L-PI-04-129
10 CFR 50.90

Prairie Island Nuclear Generating Plant Units 1 and 2
Dockets 50-282 and 50-306
License Nos. DPR-42 and DPR-60

License Amendment Request (LAR) to Revise the Spent Fuel Pool Criticality Analyses and Technical Specifications (TS) 3.7.17, "Spent Fuel Pool Storage" and 4.3, "Fuel Storage"

License Amendment Request (LAR) to Revise the Spent Fuel Pool Criticality Analyses and Technical Specifications (TS) 3.7.17, "Spent Fuel Pool Storage" and 4.3, "Fuel Storage"

Figure 3.7.17-1
Spent Fuel Pool Unrestricted Region Burnup and Decay Time Requirements ~~OFA Fuel~~
Use Figure based on Westinghouse Calculation CN-WFE-03-40 Figure 4-5

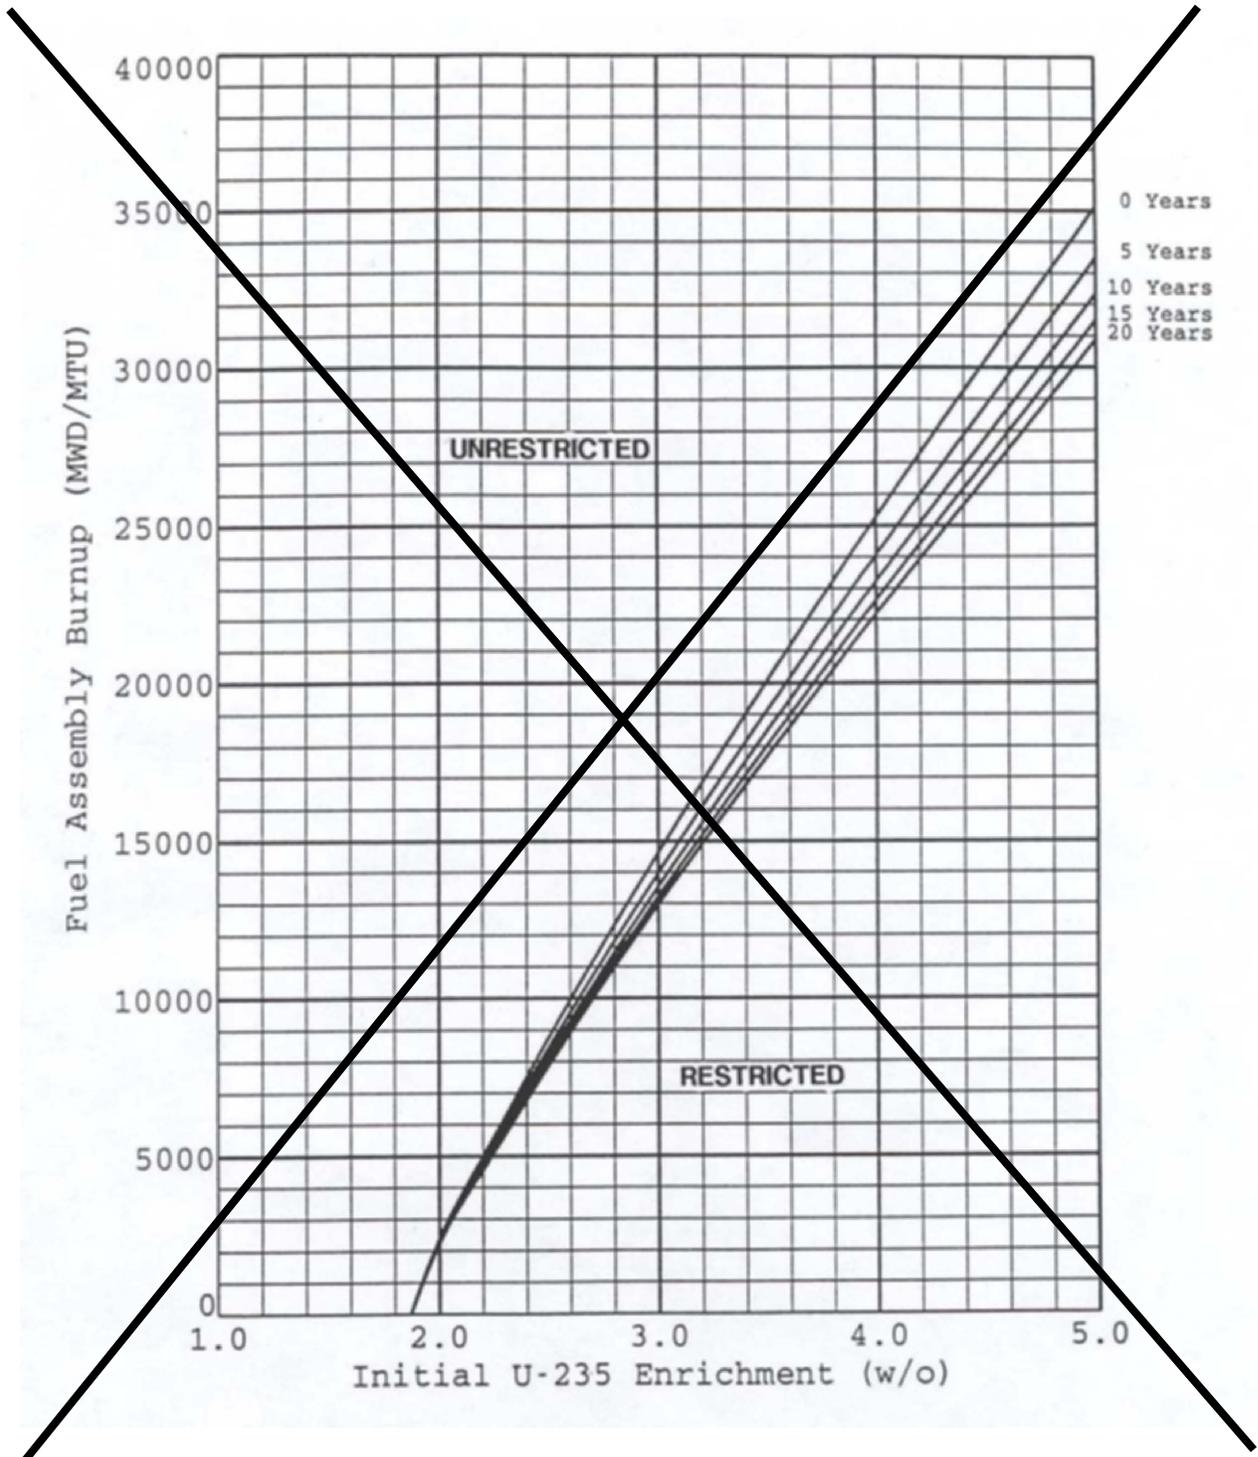
Analysis,” Reference 1. The new SFP “All-Cell” criticality analyses assume a single fuel assembly type that bounds all other fuel types. Thus, only a single figure is required in LCO 3.7.17. A new Figure 3.7.17-1 is provided for the “All-Cell” configuration based on the results of the new criticality analyses. Figure 3.7.17-2 and references to it have been deleted in the LCO statement and SR 3.7.17.1.

LCO 3.7.17 The combination of initial enrichment, burnup and decay time of each fuel assembly stored in the spent fuel pool shall be within the Unrestricted Region of Figure 3.7.17-1 ~~or Figure 3.7.17-2, as applicable,~~ or in accordance with Specification 4.3.1.1.

~~Figure~~ ~~IGURE~~ 4.3.1-1
Spent Fuel Pool Burned/Fresh Checkerboard Cell Layout

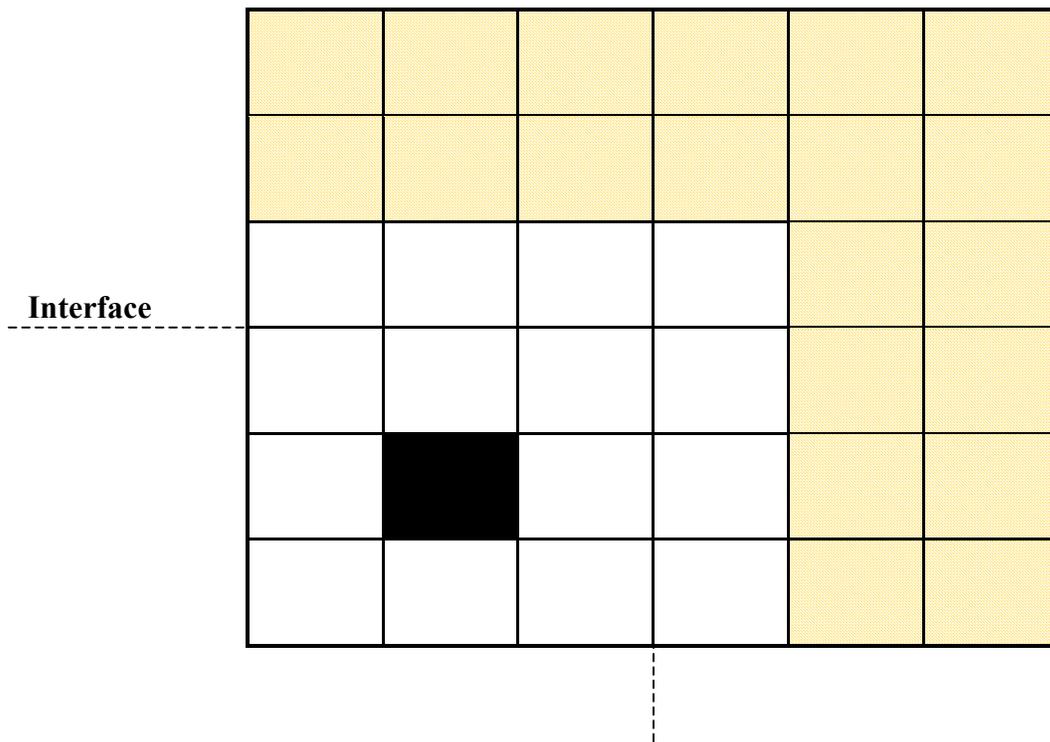
Burned Fuel: Must satisfy minimum burnup requirements of
Figures 4.3.1-3 ~~or through 4.3.1-4 12~~ depending on ~~number~~
~~presence~~ of GAD rods in fresh fuel

Figure ~~IGURE~~ 4.3.1-2
Spent Fuel Pool Checkerboard Interface Requirements

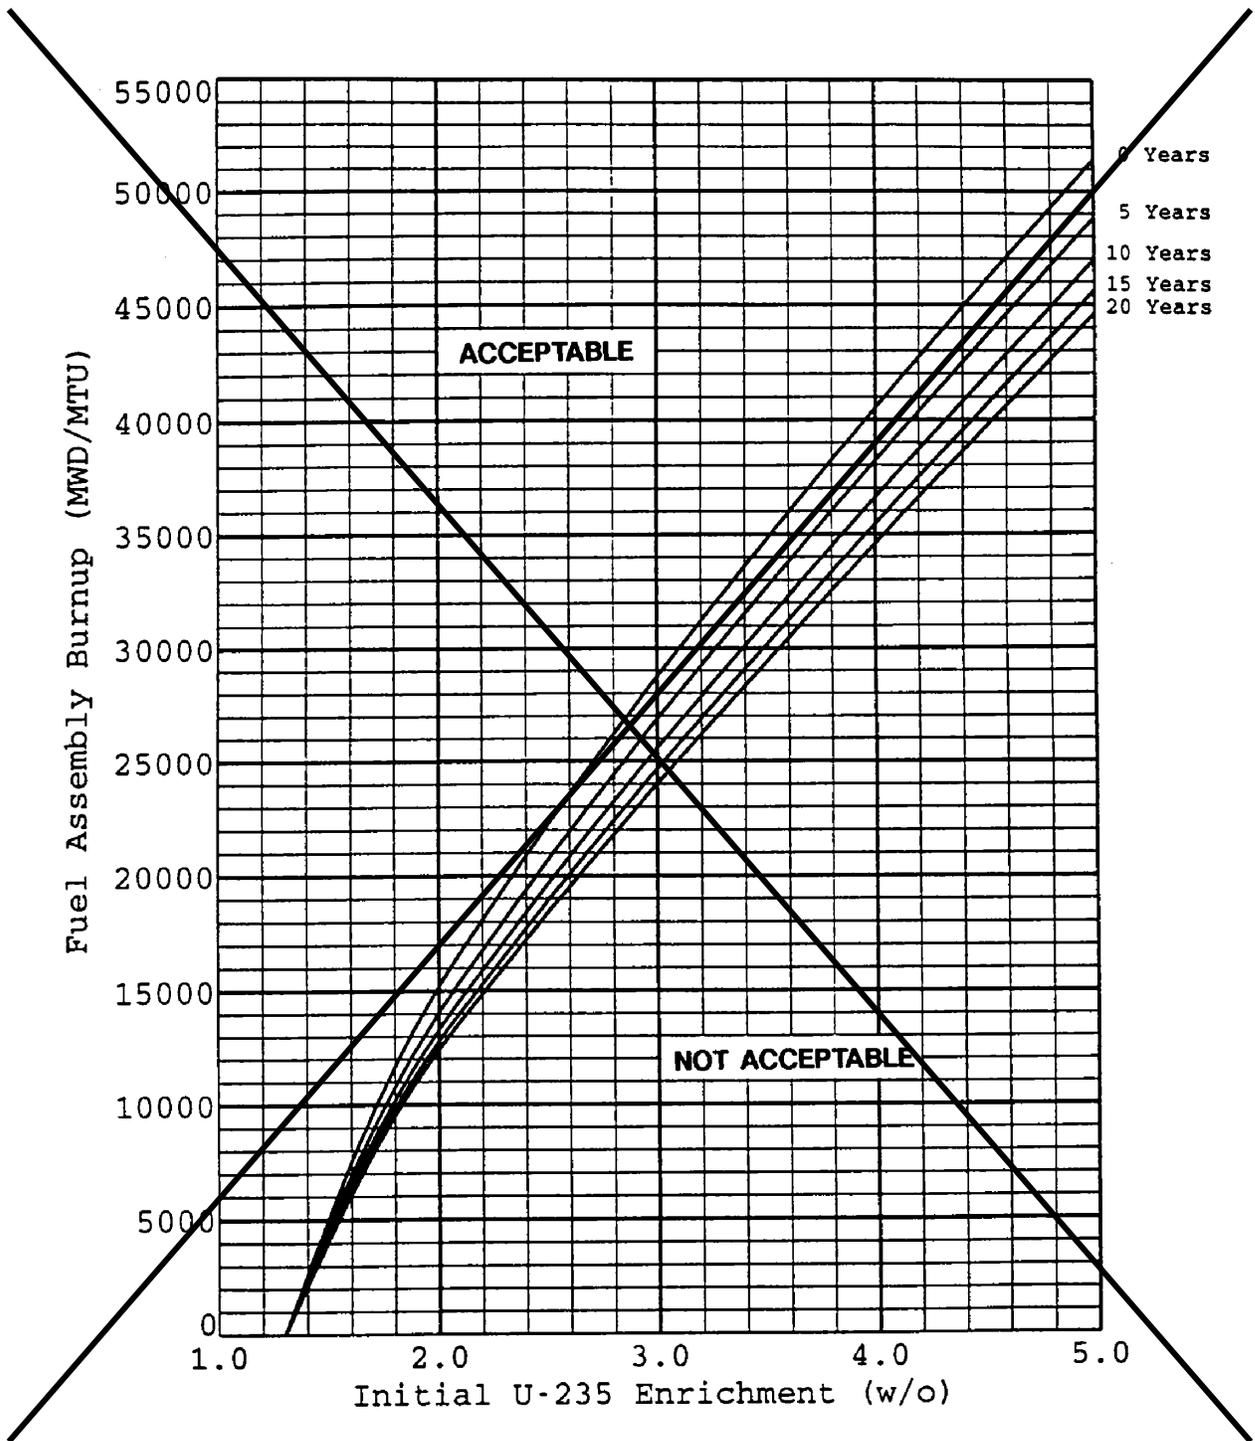
Use Figure based on Westinghouse Calculation CN-WFE-03-40 Figure 4-6

FIGURE 4.3.1-5 Spent Fuel Pool Checkerboard Region Burnup and Decay Time Requirements—OFA Fuel, 4 GAD

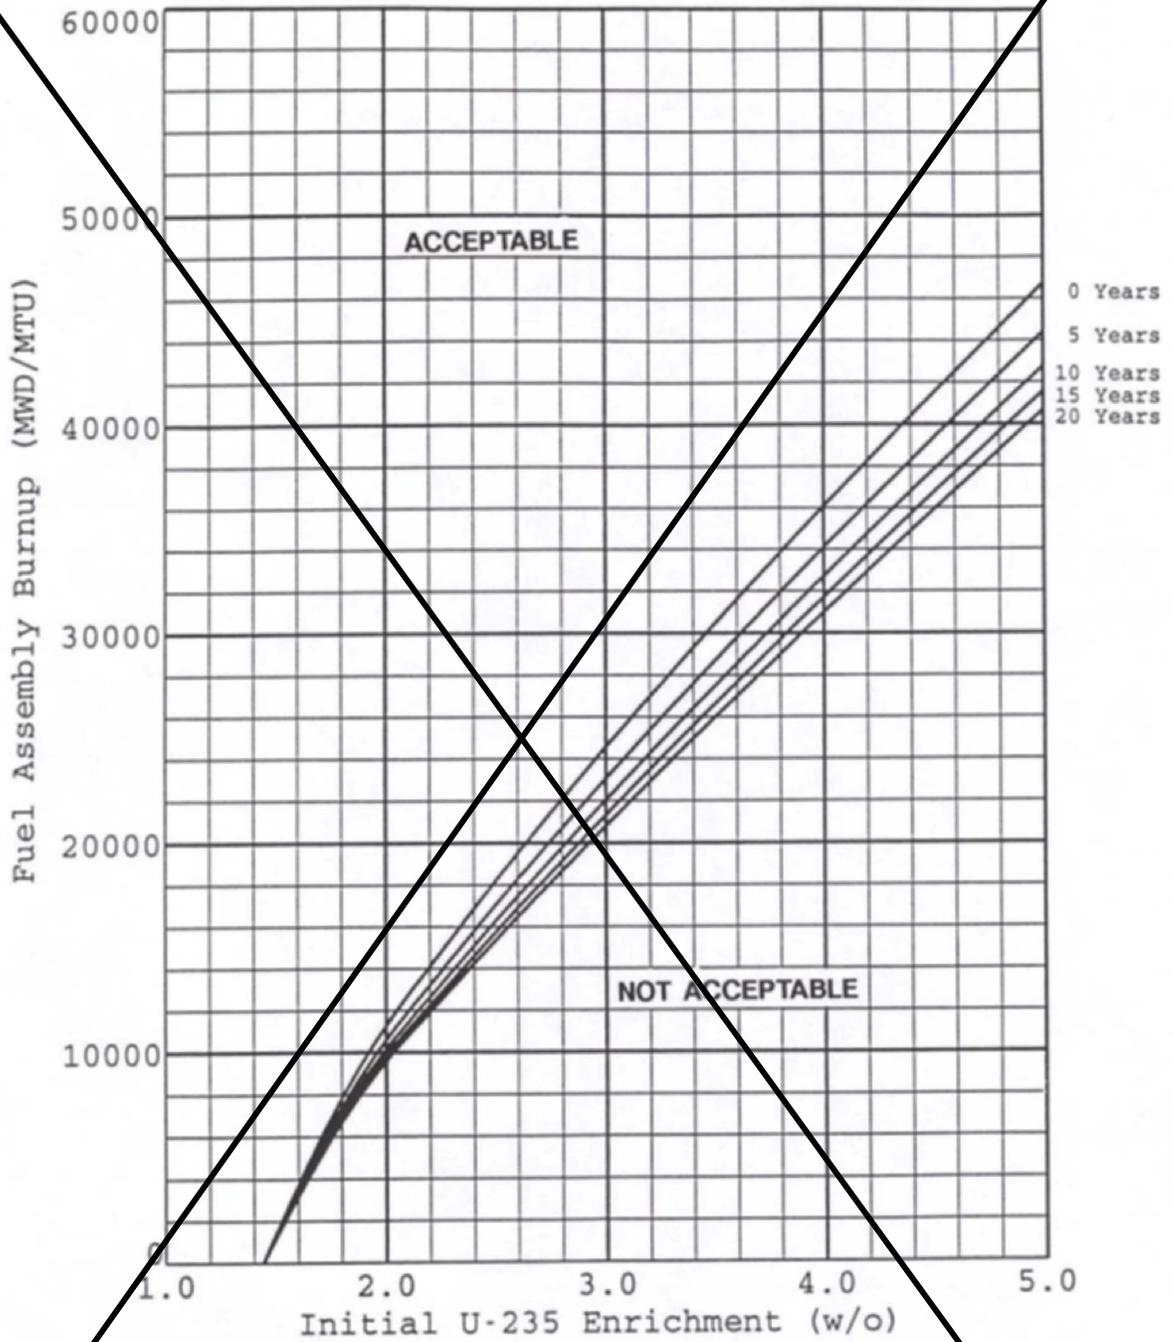
Figure deleted

FIGURE 4.3.1-6 Spent Fuel Pool Checkerboard Region Burnup and Decay Time Requirements—STD Fuel, 4 GAD

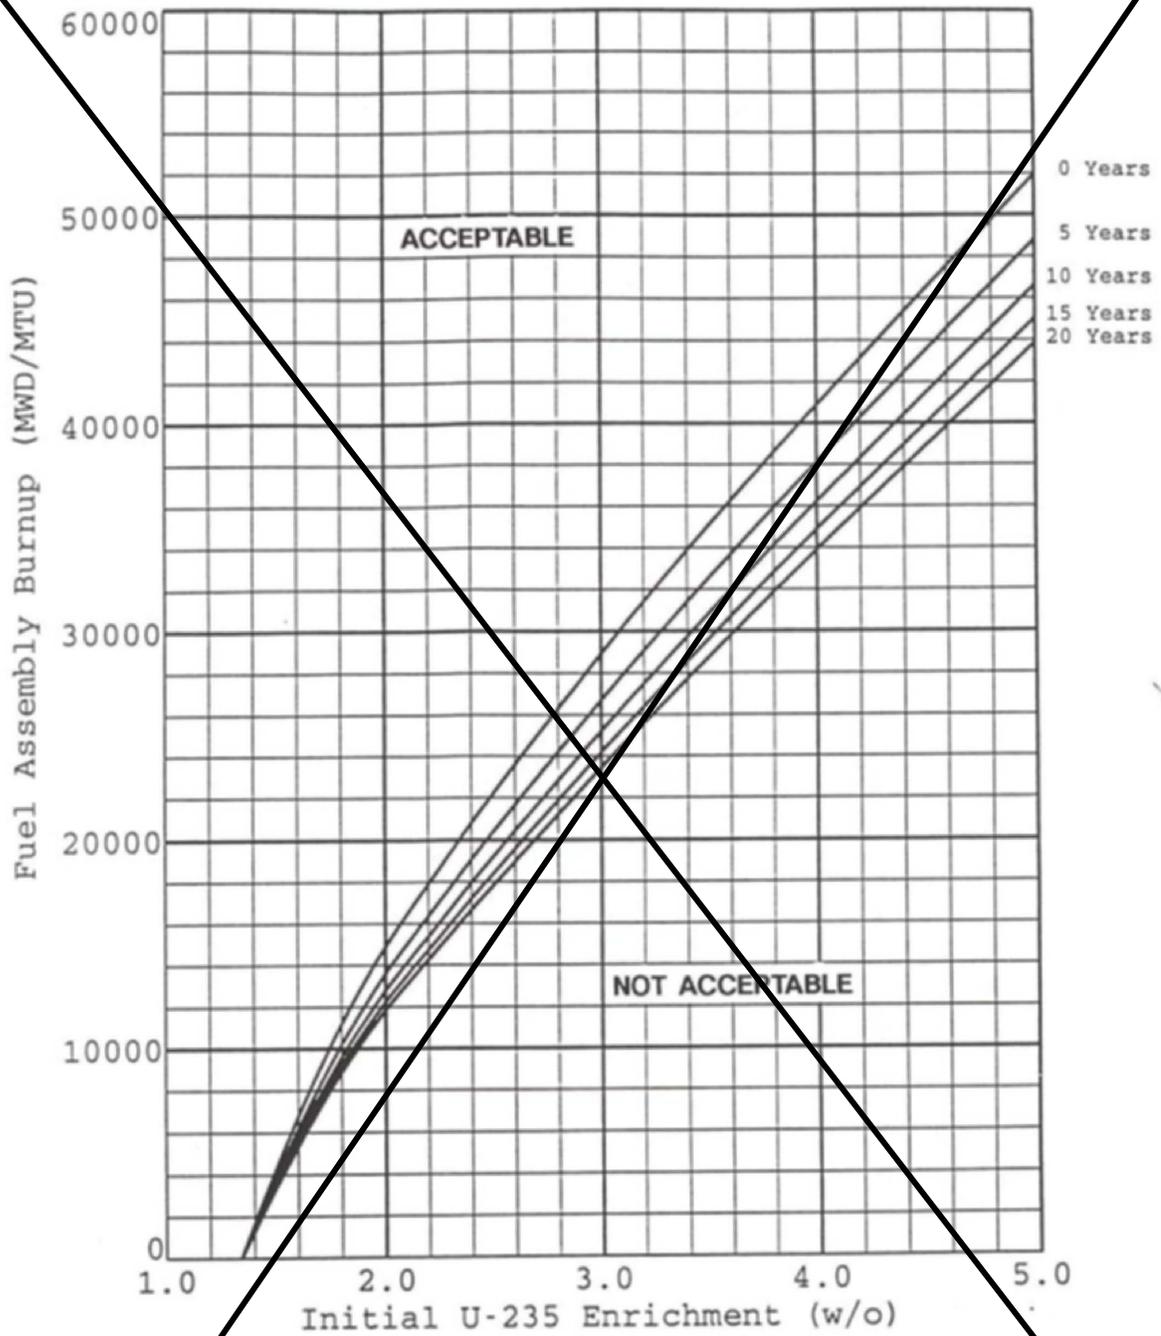
Figure Deleted

FIGURE 4.3.1-8 Spent Fuel Pool Checkerboard Region Burnup and Decay Time Requirements—STD Fuel, 8 GAD

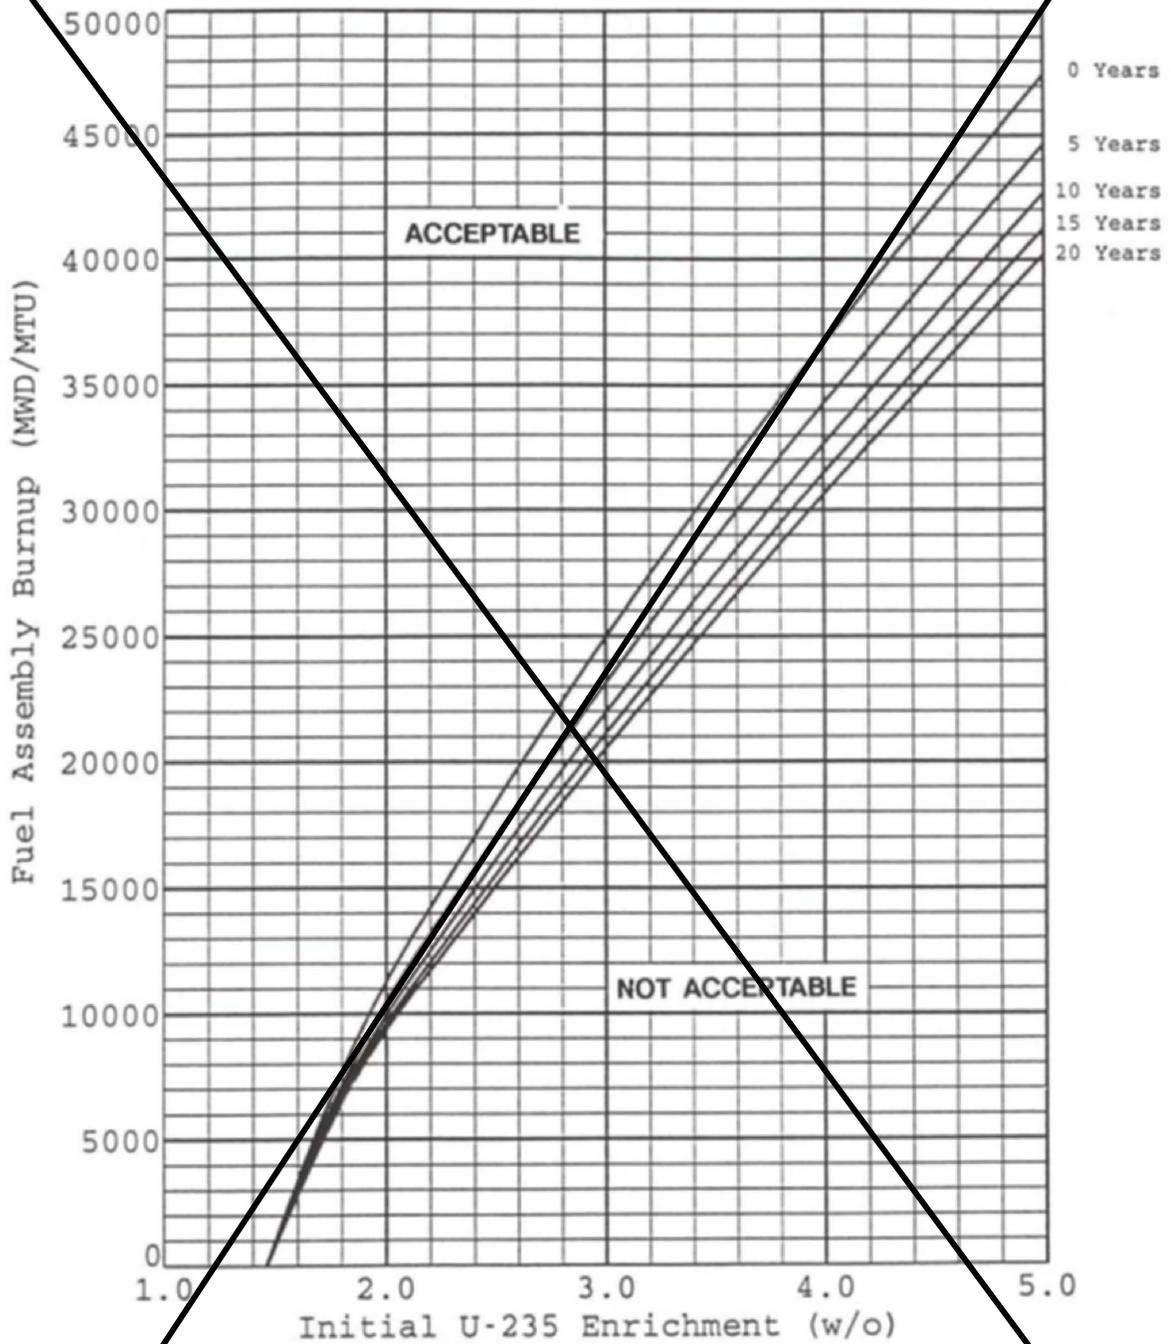
Figure deleted

FIGURE 4.3.1-9 Spent Fuel Pool Checkerboard Region Burnup and Decay Time Requirements—OFA Fuel, 12 GAD

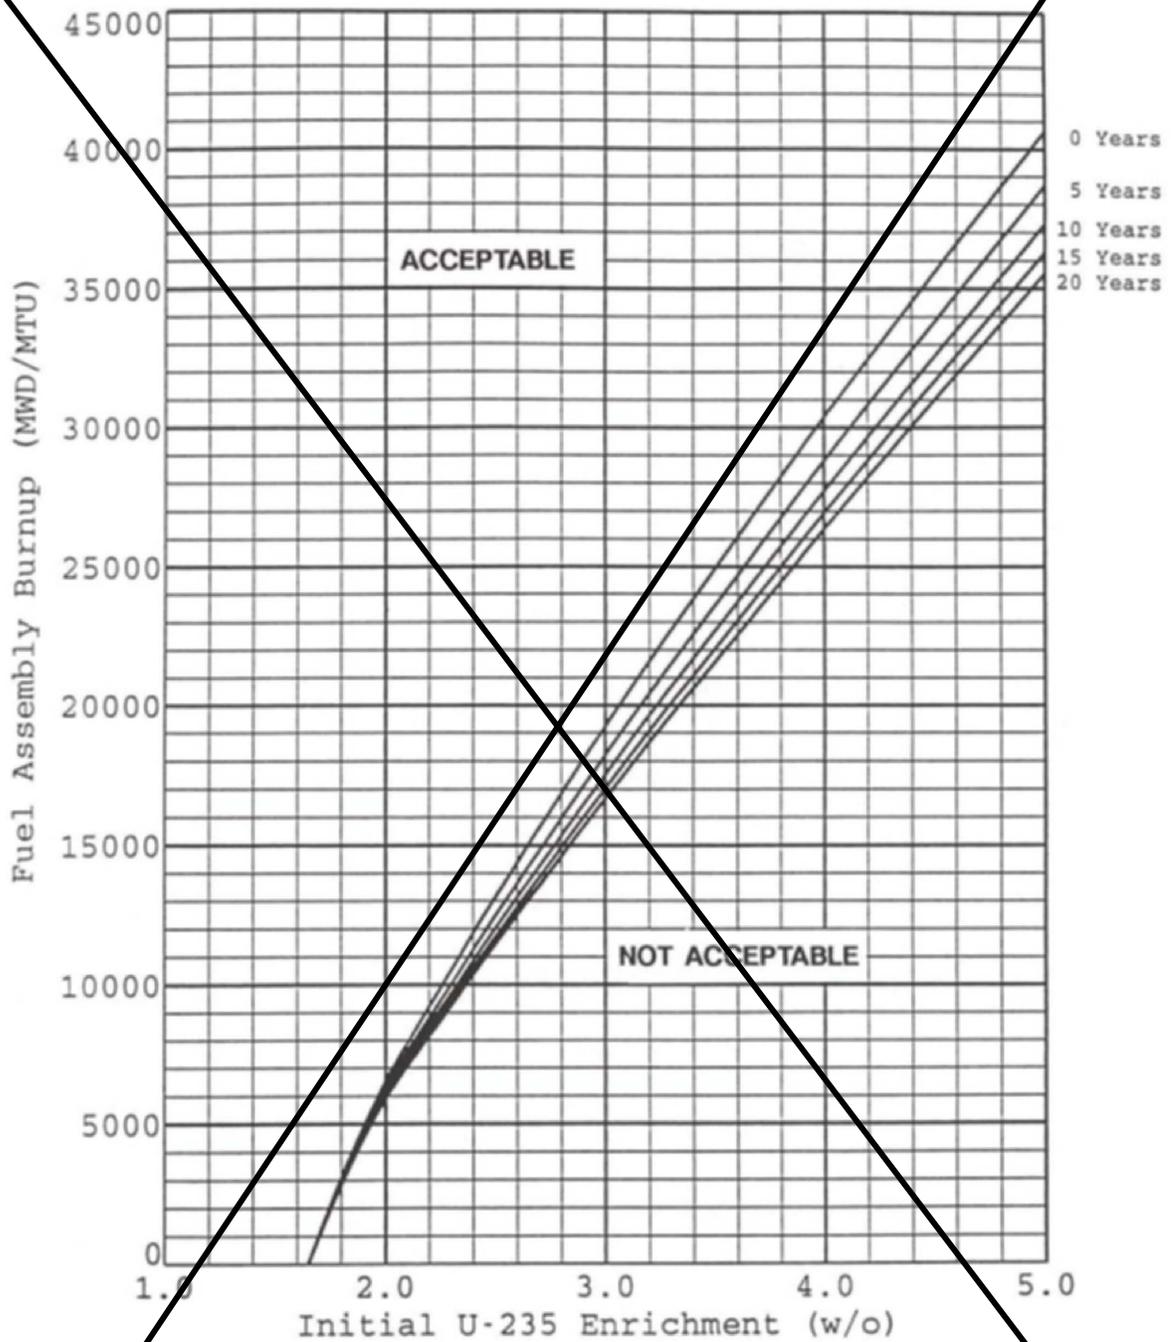
Figure deleted
